SUBJECT: Forwards addl info re safe loadpaths, testing of crane controls & special lifting devices, for review of response to NUREG-0612, "Control of Heavy Loads at Nuclear Power Plants."

November 9, 1984
L-84-327

Re: St. Lucie Unit 2
Docket No. 50-389
Control of Heavy Loads
License Condition 2.C.12

Technical evaluation report EGG-HS-6263 was provided with the NRC letters dated May 31, 1983 and June 17, 1983. This report provided the results of the NRC contractor's review of Florida Power & Light's response to NUREG-0612, "Control of Heavy Loads at Nuclear Power Plants" for St. Lucie Unit 2.

62' ELEVATION - PRESSURIZER MISSILE SHIELD (LOAD PATH)

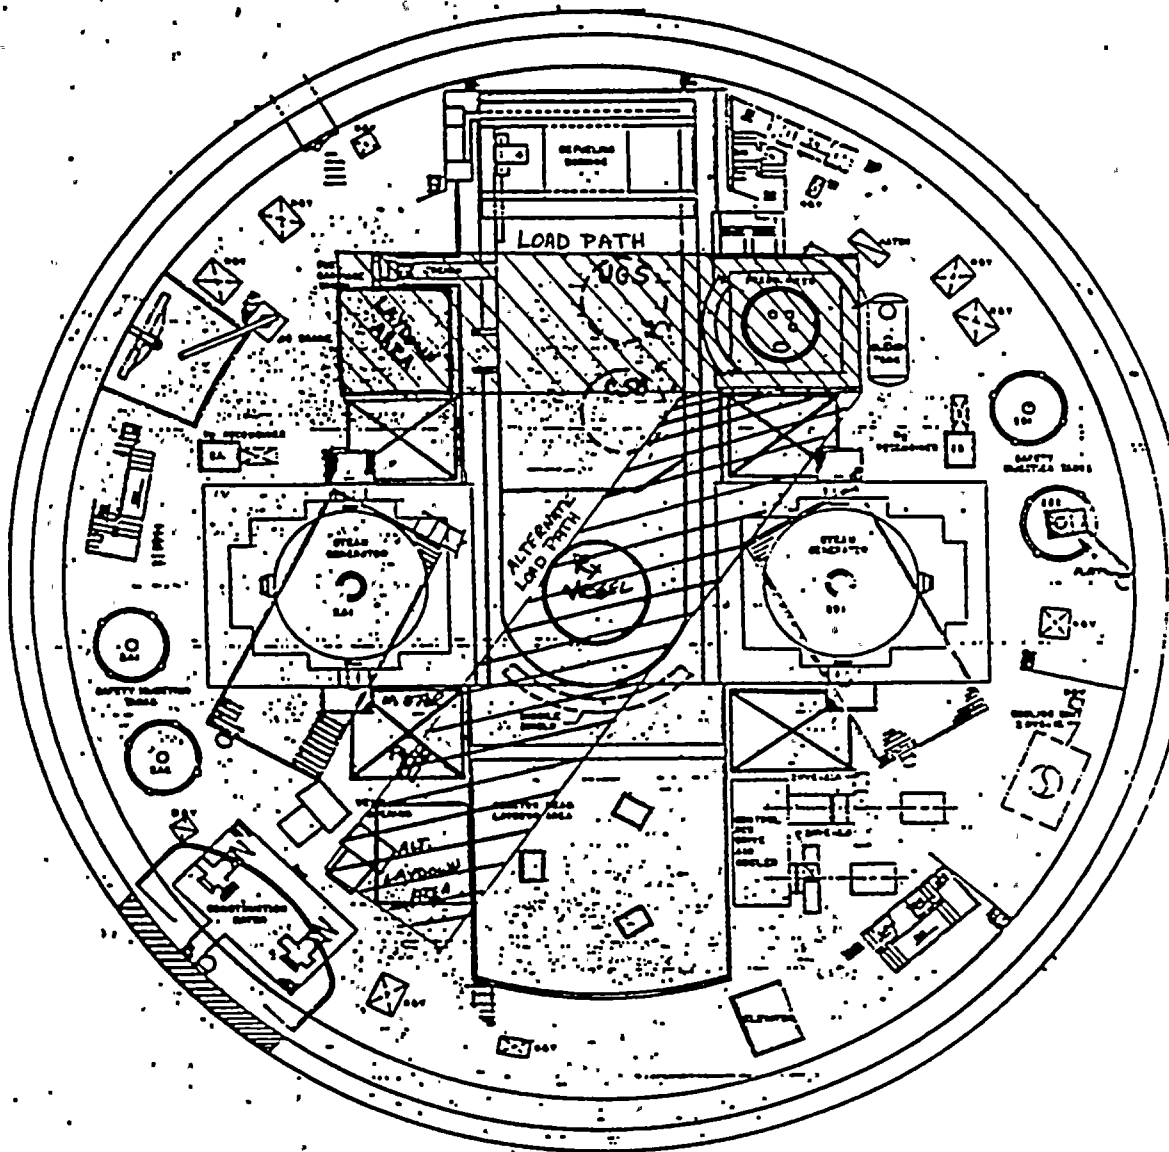
In those locations where safe loadpaths are not marked and the "Safe Load Area" concept is used, require an employee (rigger) to lead the heavy load over the path when handling is required.

As discussed in the telephone conference with the reviewers, FPL has prepared specific loadpaths for major loads which routinely take the same route or routes when carried. These paths are referenced in the applicable procedure, and are attached. In addition, FPL uses an individual to lead the heavy load over the path when handling is required.
